**RELEASED FOR  
 FABRICATION / INSTALLATION**  
 PPPL Drafting:

Oak Ridge National Laboratory managed for the DEPARTMENT OF ENERGY under U.S. GOVERNMENT contract DE-AC05-00OR22725 UT-BATTELLE, LLC, Oak Ridge, Tennessee PROJECT NAME						
NATIONAL COMPACT STELLERATOR EXPERIMENT VACUUM VESSEL PERIOD INSPECTION AND LEAK CHECK ASSEMBLY						
VERSION NO.	PLANT	BLDG	FL	SHT OF	TYPE	CLASS
5	X-10	5700	3	2 19	A	U
RELEASE LEVEL		SE120-004			REV	
Fabrication					2

TYPICAL PORT 6A AND 6B  
SECTION PORT06-PORT06

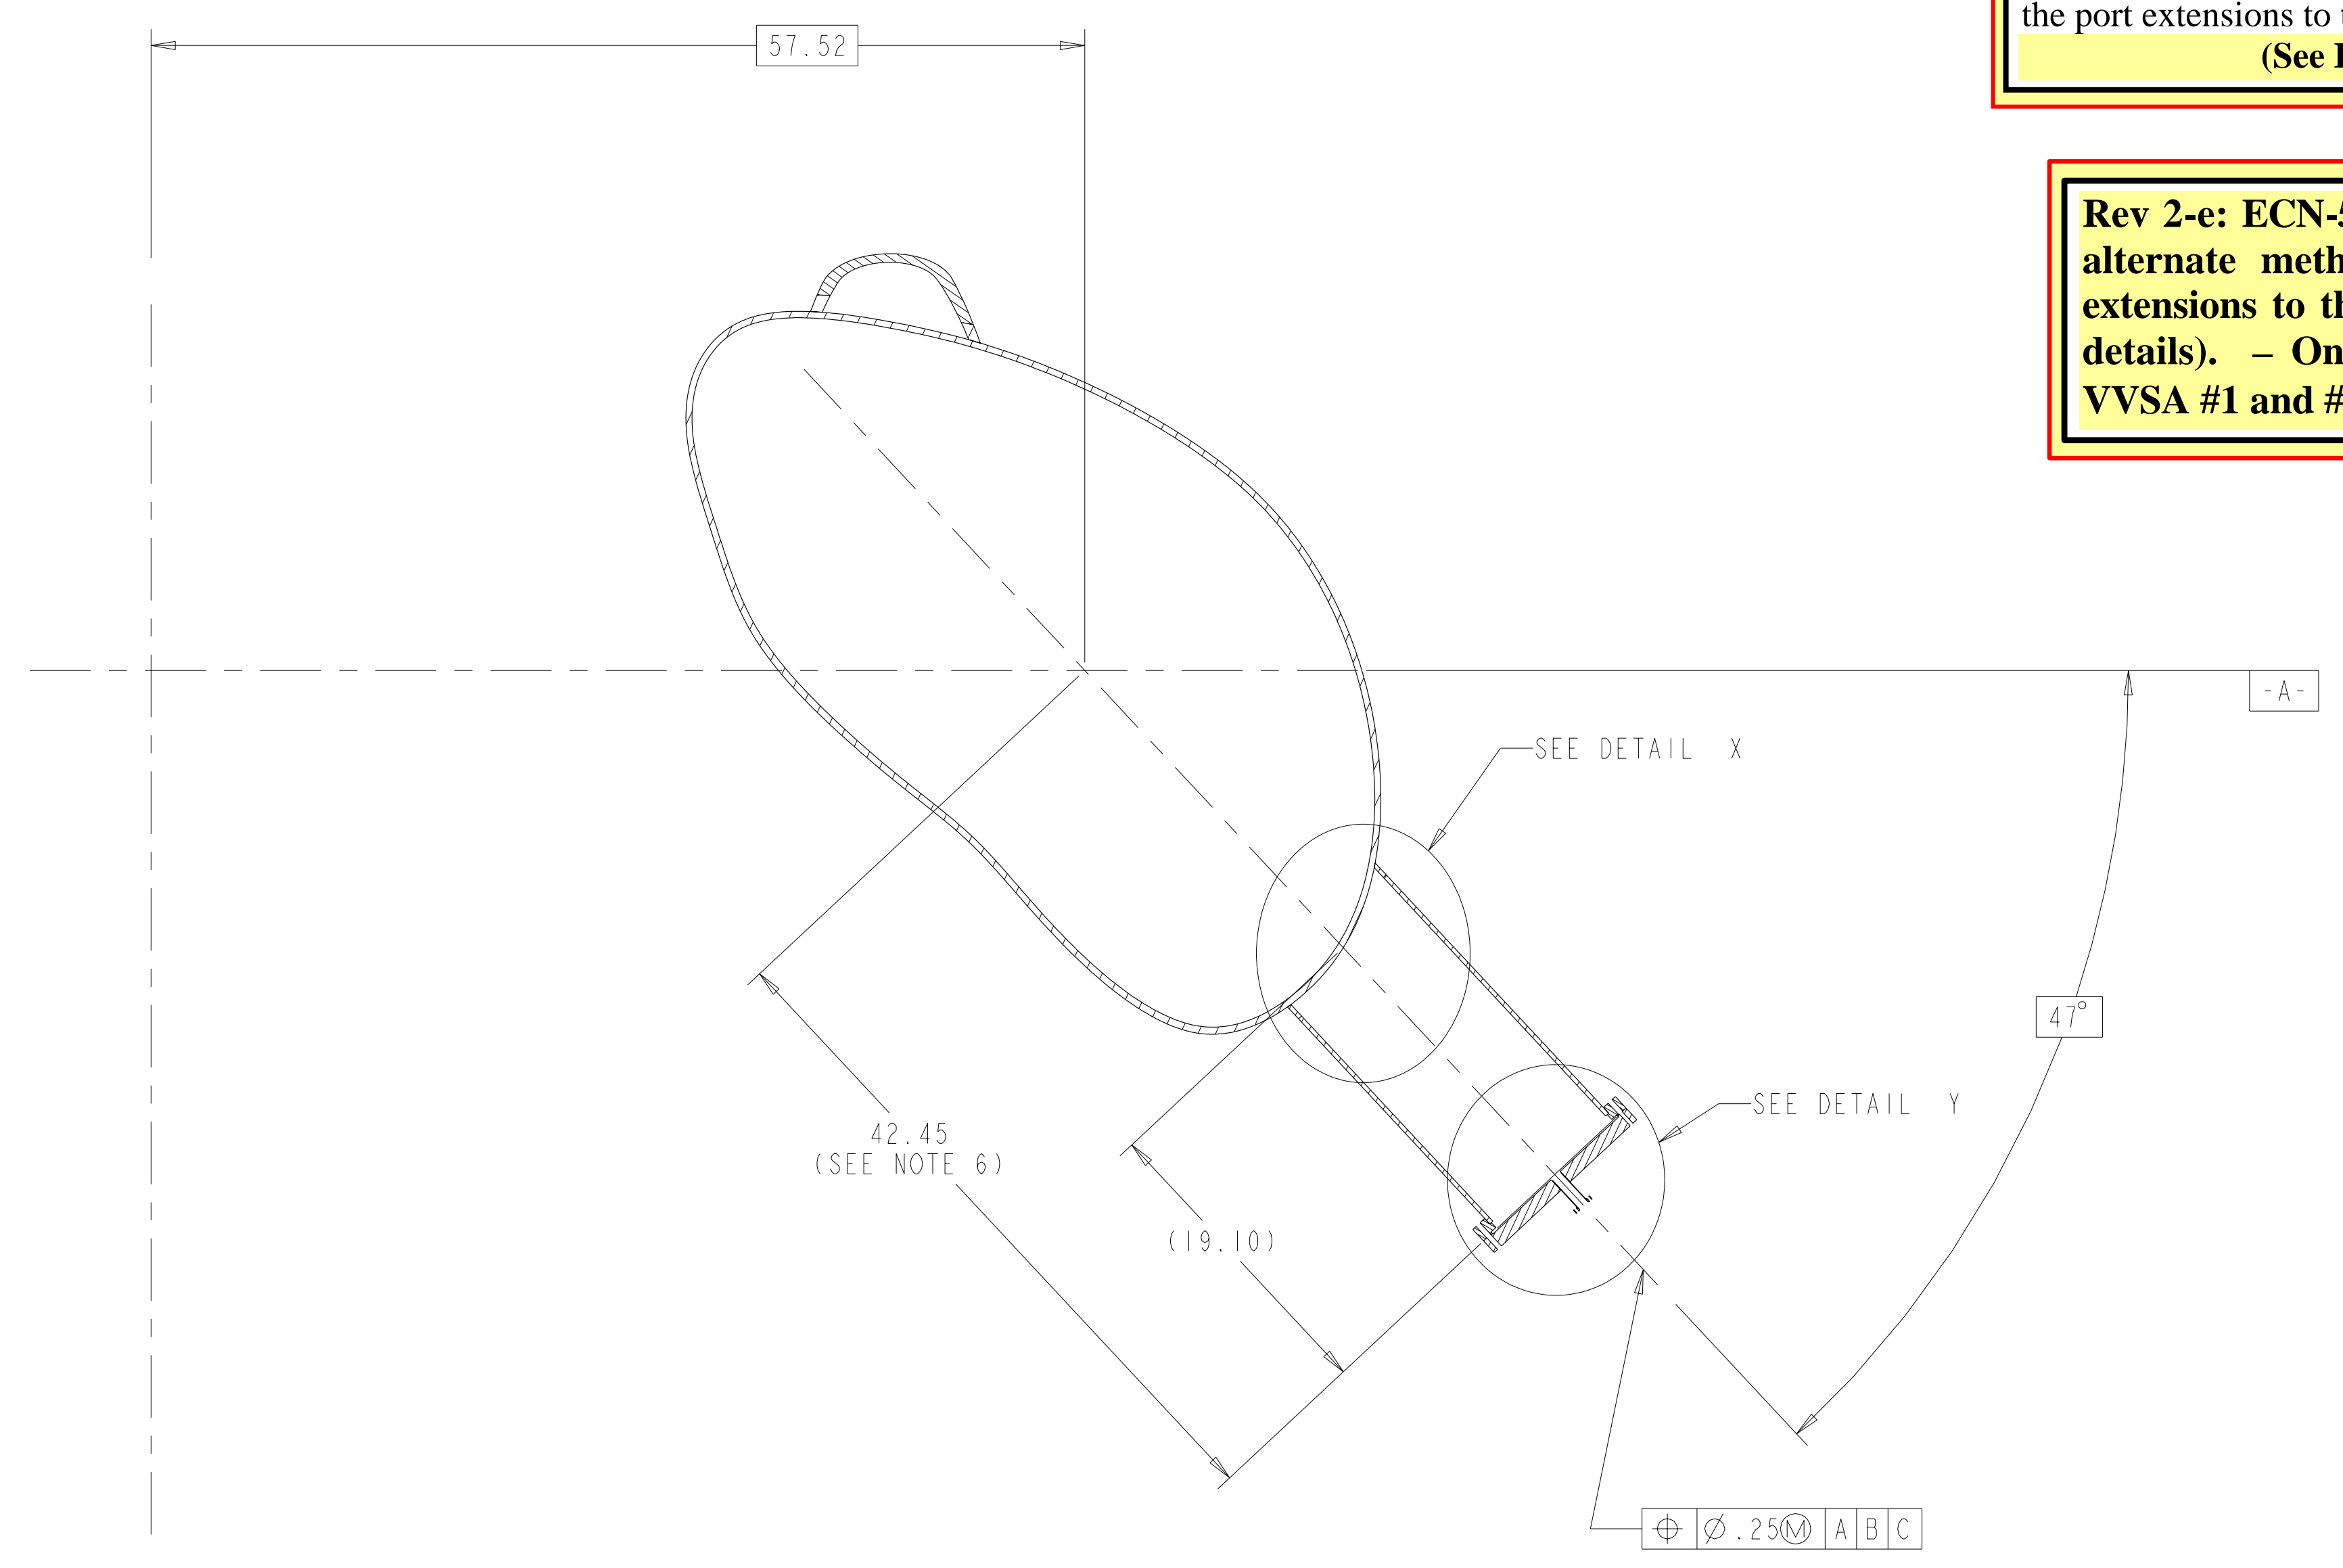
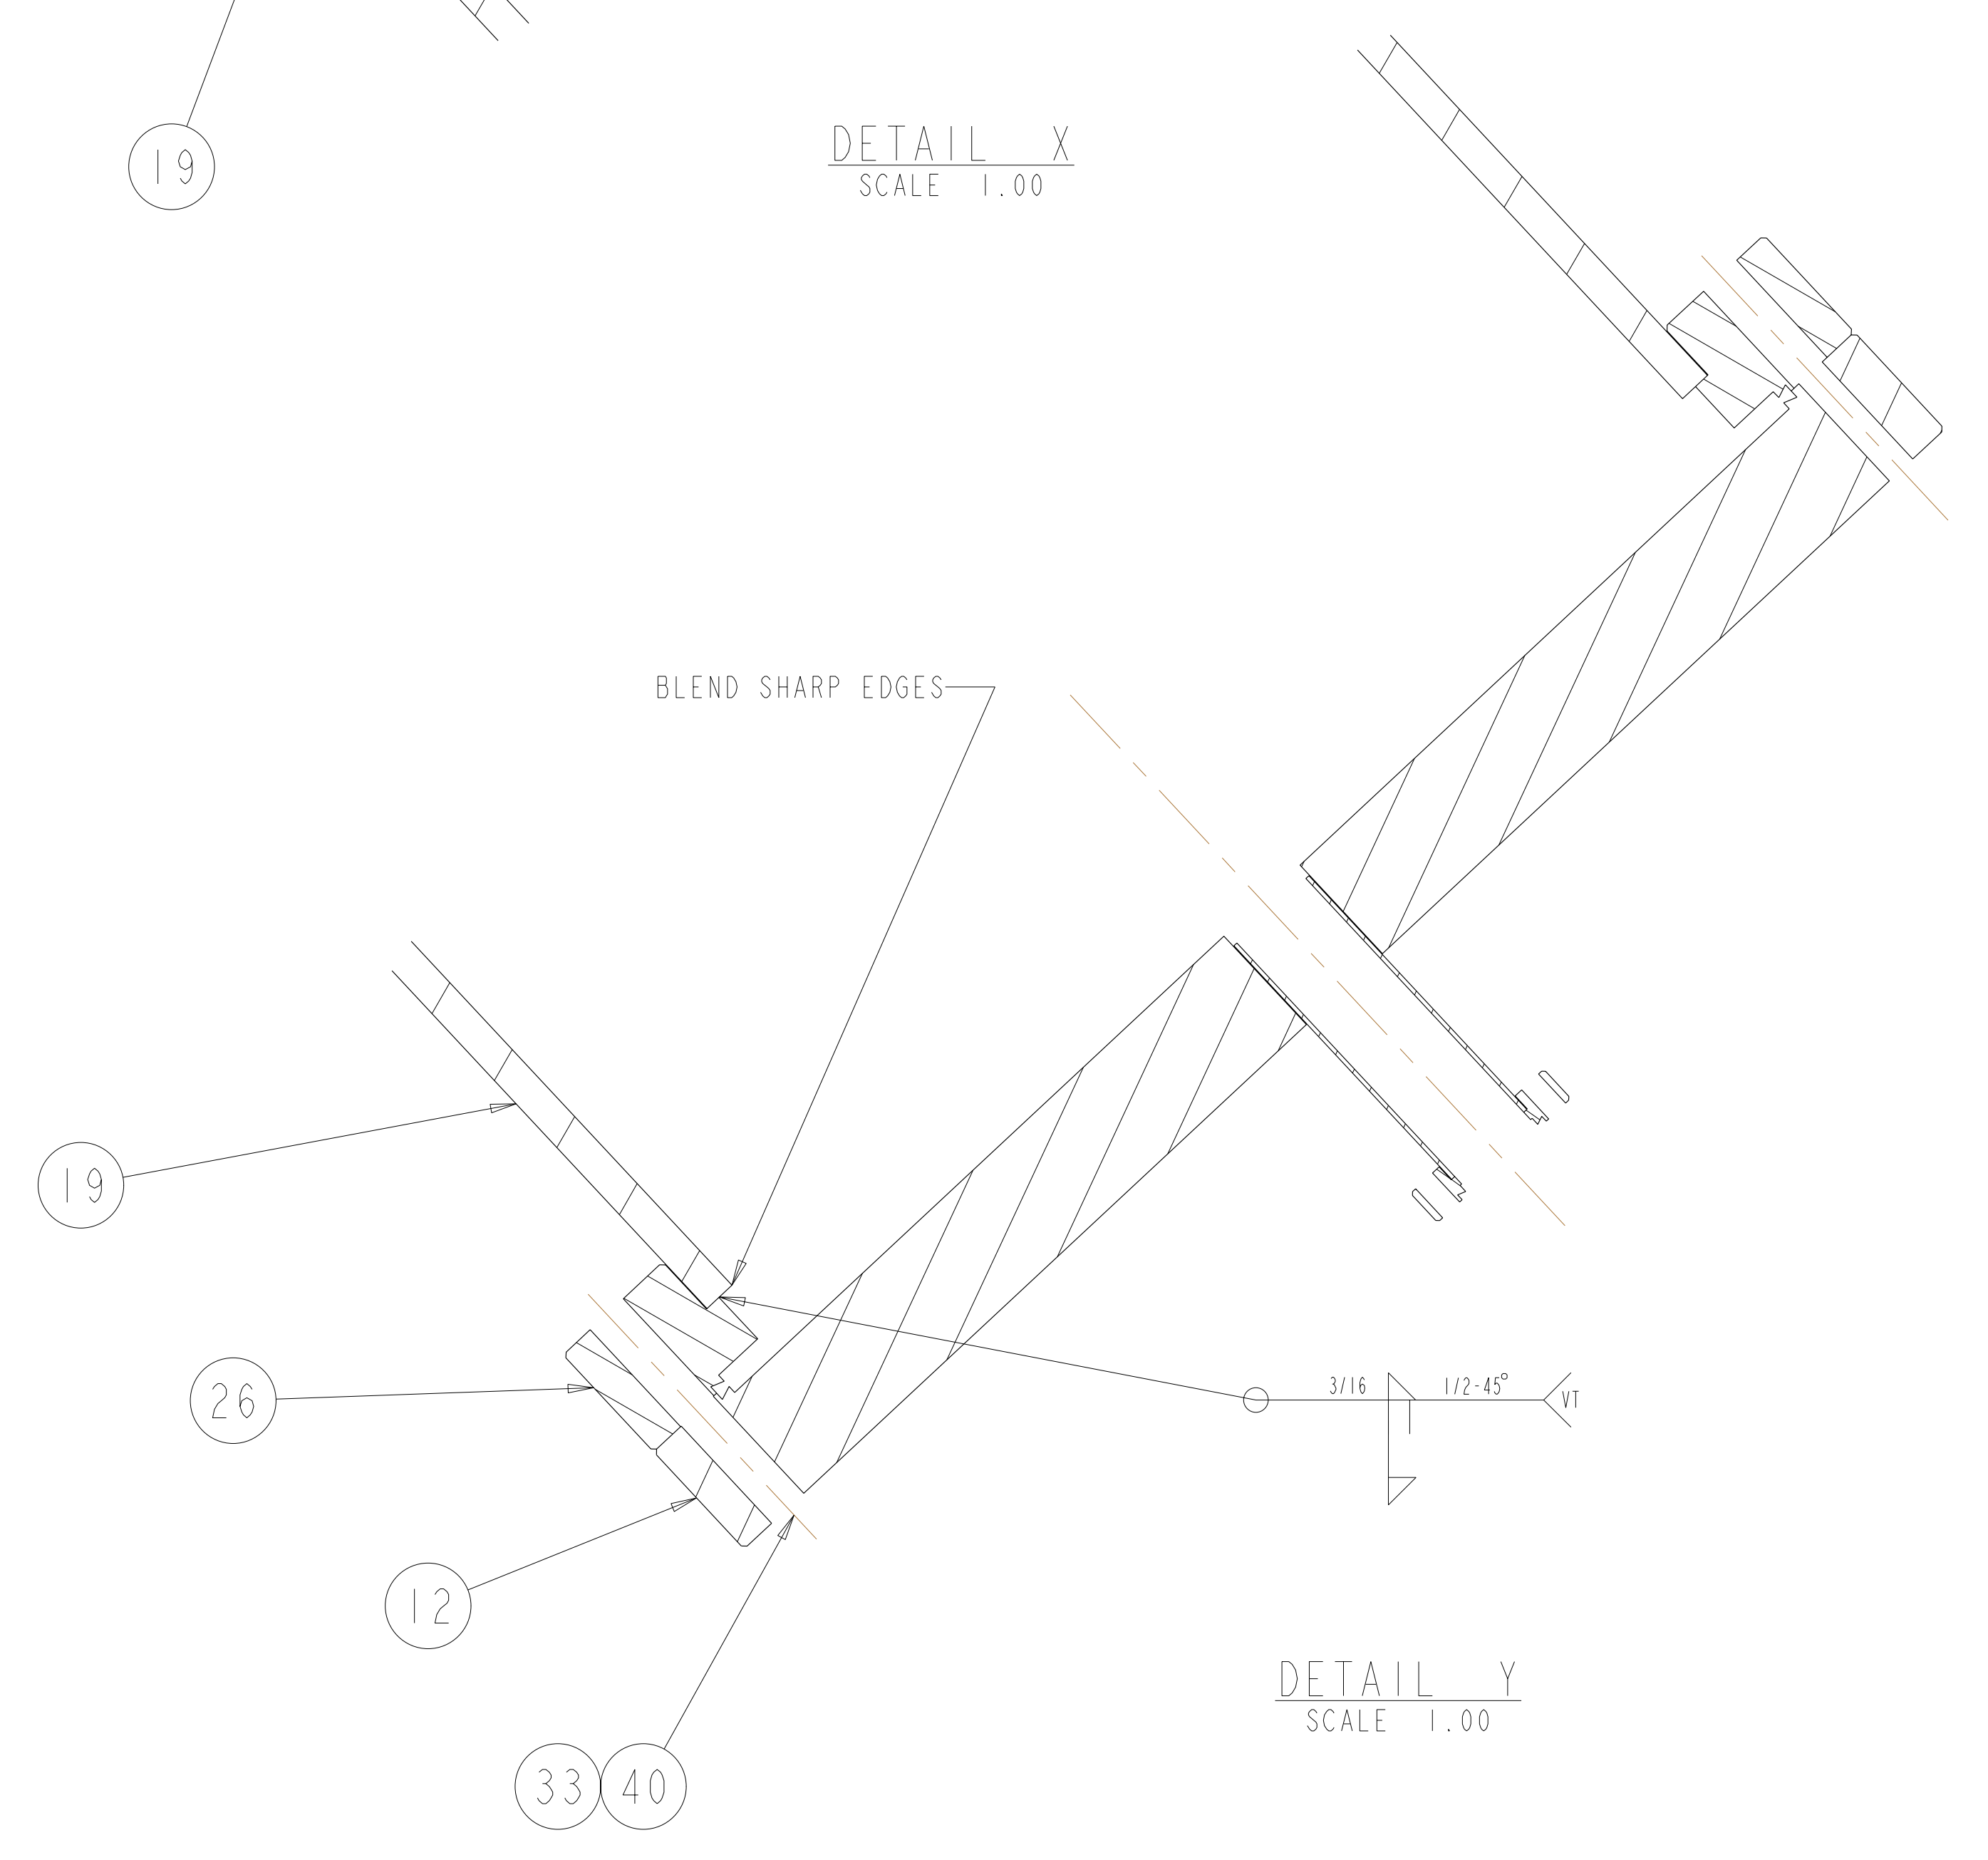
**ECN-5082.** Requirement originally included grooves to facilitate leak checking by vendor. However, vendor elected another means of leak checking and therefore the grooves are no longer required. Specifically, this ECN eliminated the leak checking groove on SE121-014 (Rev 1-c) and SE1221-091 (Rev 0-a). Additionally, this ECN added a missing weld symbol to SE121-004 (Sheets 4 through 19) for joining the port extensions to the vessel (Rev 2-d).  
 (See ECN-5082 for details)

**Rev 2-e: ECN-5021 (RFD-12-017) approved alternate methods for welding the port extensions to the VVSA (See ECN-5021 for details). - Only applicable to VVSA #3 - VVSA #1 and #2 covered by NCR 19464.**
